ROADWAY DESIGN BULLETIN 22-05

SUBJECT: **Audible and Vibratory Treatments for Arterials and Collectors**

This Bulletin introduces revisions to the *FDOT Design Manual (FDM)* and *FDOT Standard Plans for Road and Bridge Construction (Standard Plans)* to streamline and improve the Department's criteria and construction details for Audible and Vibratory Treatments (AVTs) on arterials and collectors.

INDEX
546-010-1

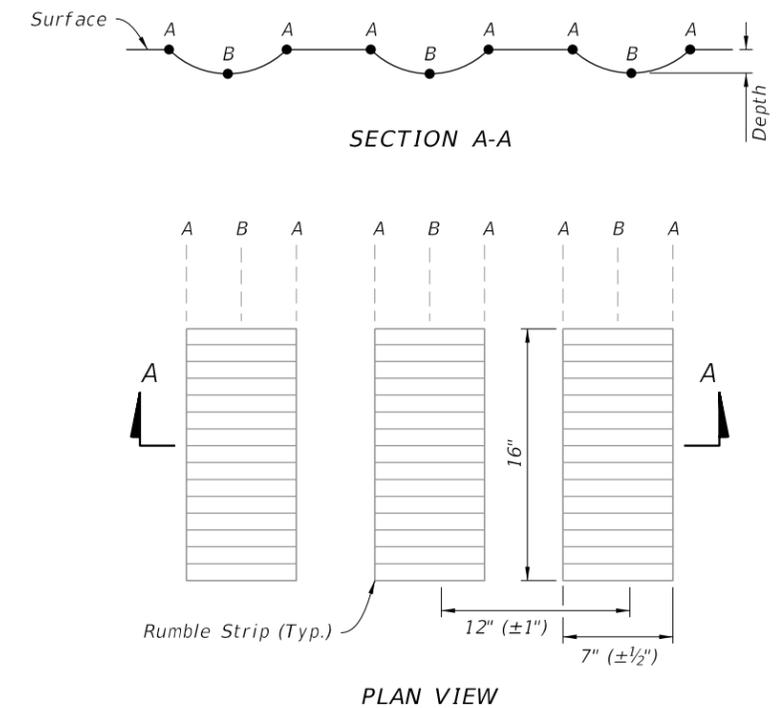
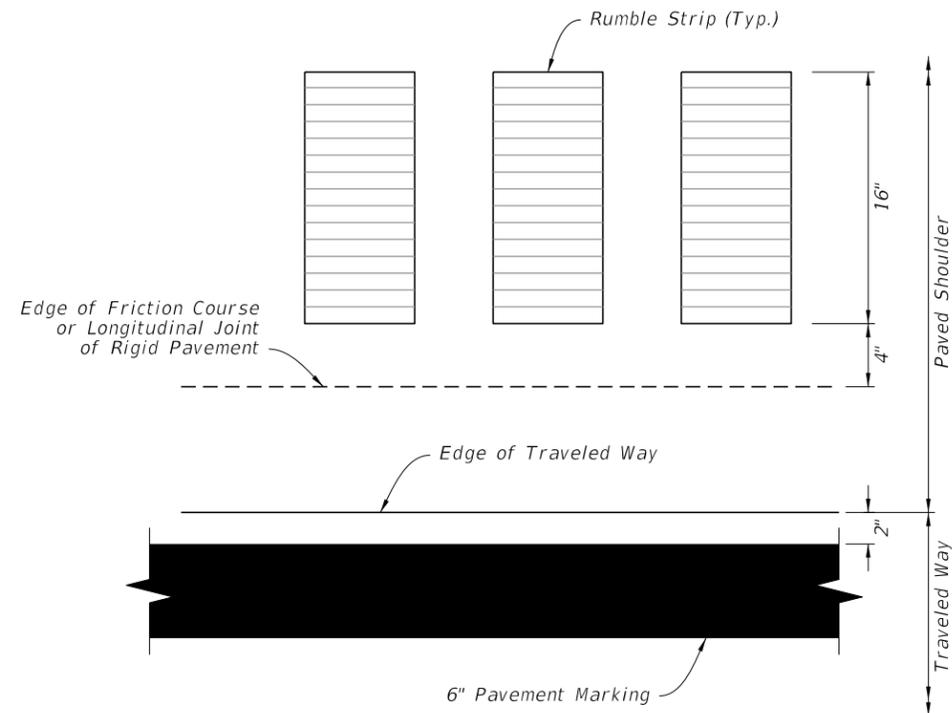
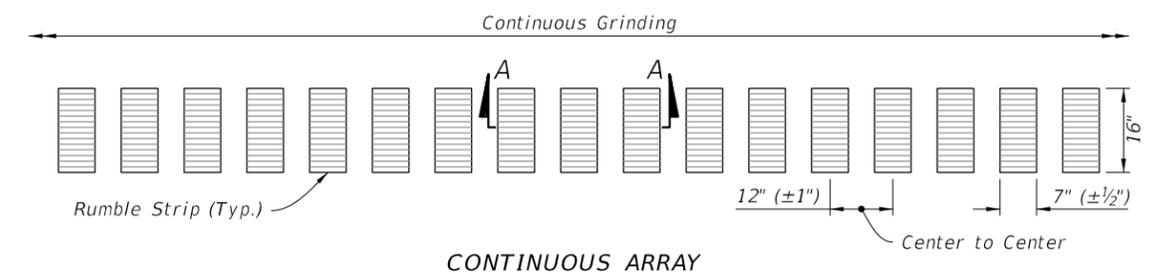
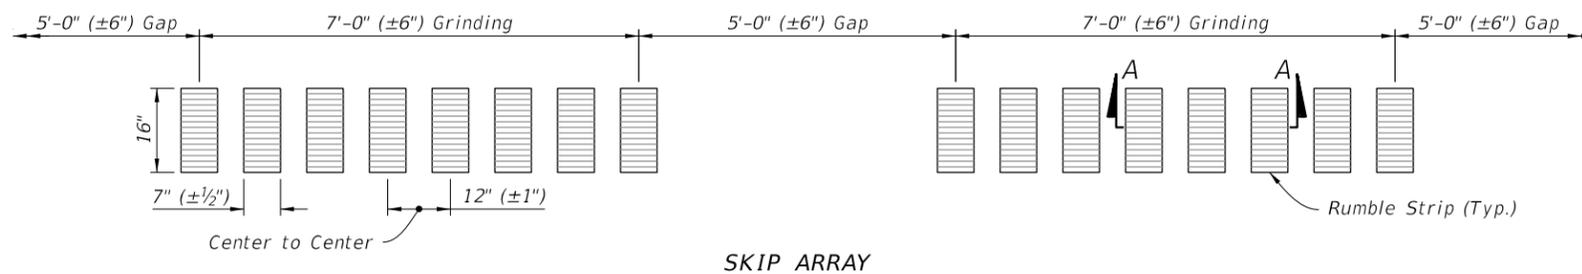
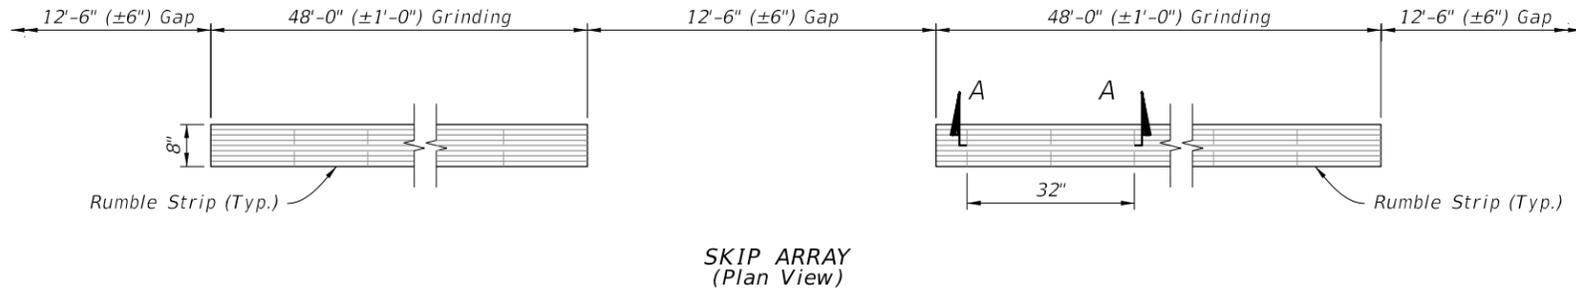
DESCRIPTION:
Revised Index to only include cylindrical rumble strips for limited access facilities.

INDEX
546-020

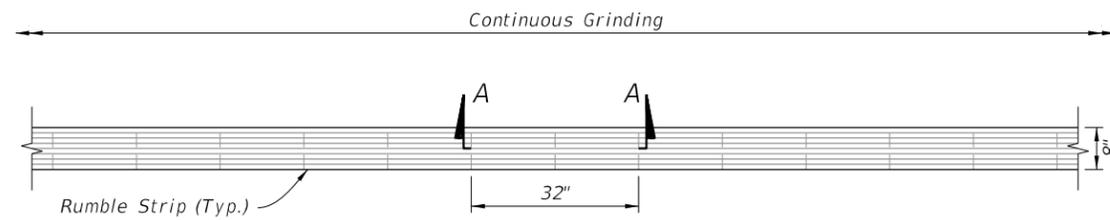
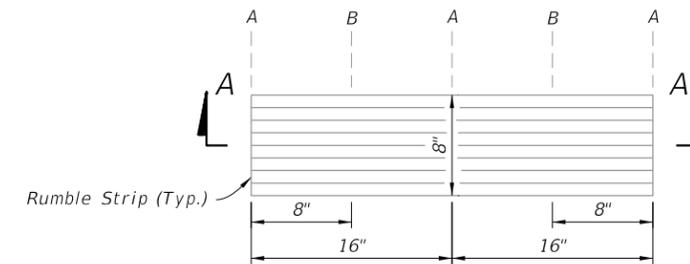
REVISION DESCRIPTION:
New Index to only include sinusoidal rumble strips for arterials and collectors.

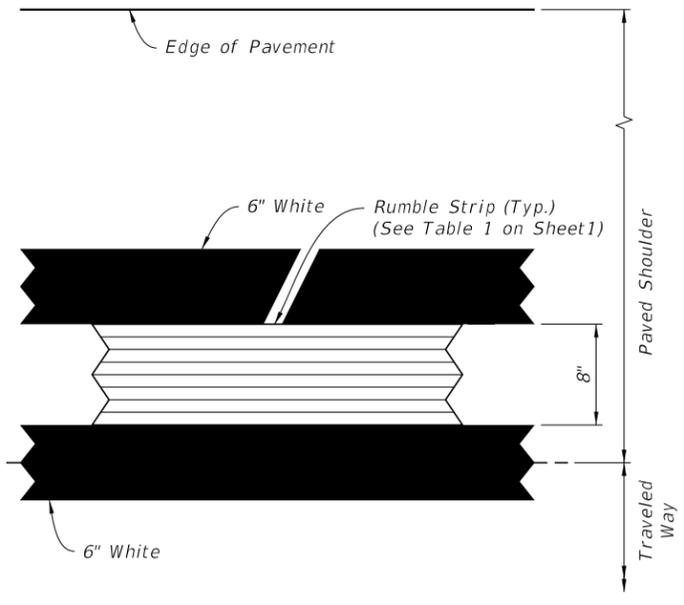
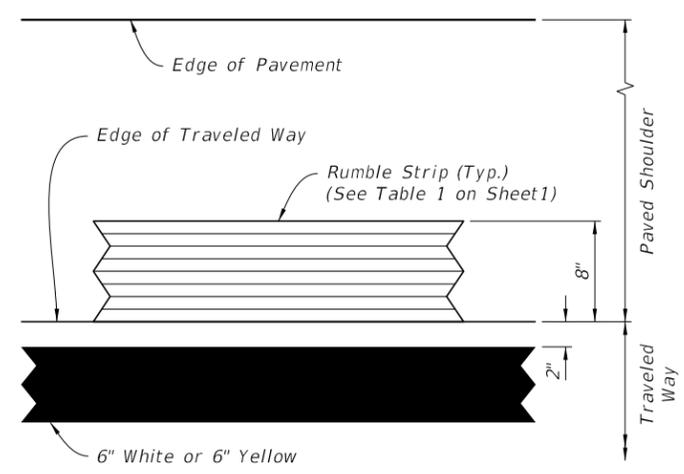
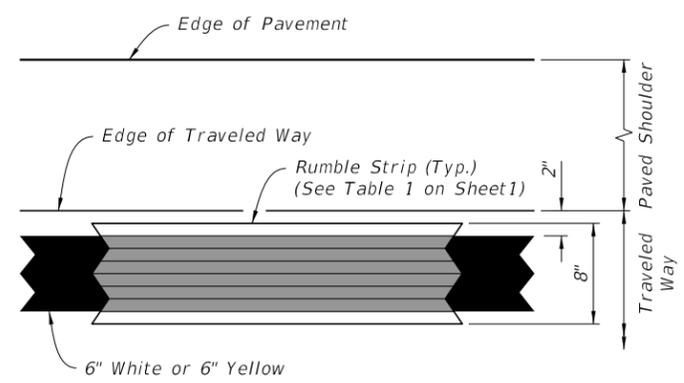
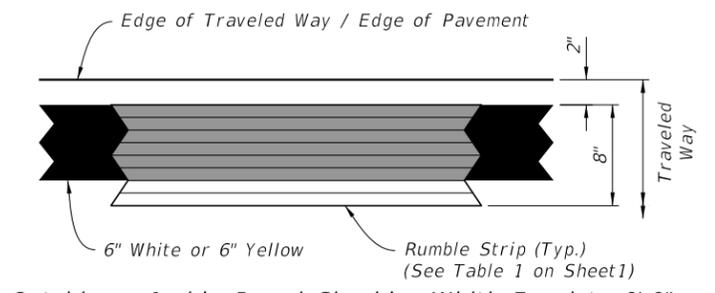
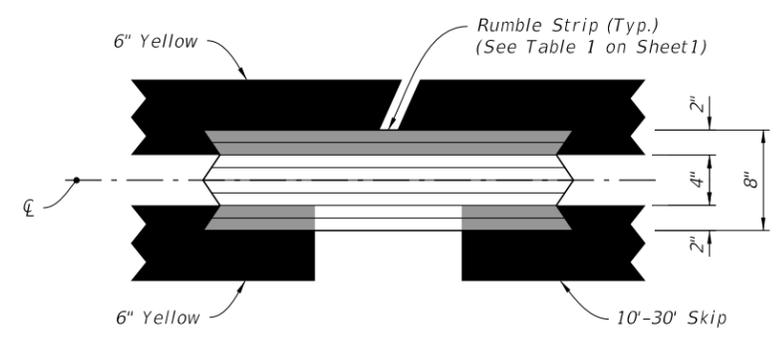
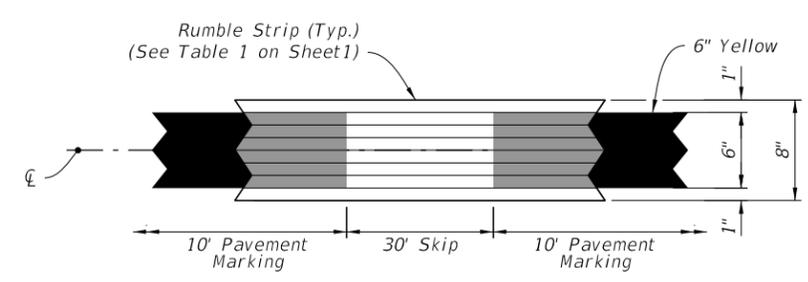
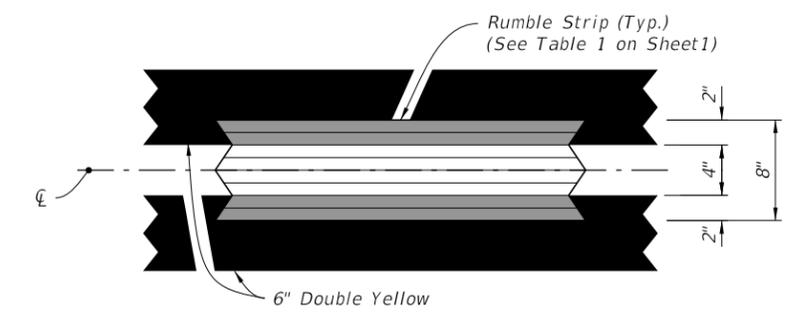
LAST REVISION 10/2022	REVISION	DESCRIPTION: New Index to only include sinusoidal rumble strips for arterials and collectors.		FY 2023-24 STANDARD PLANS	GROUND-IN RUMBLE STRIPS - ARTERIALS AND COLLECTORS	INDEX 546-020	SHEET 2 of 2
-----------------------	----------	--	--	------------------------------	---	------------------	-----------------
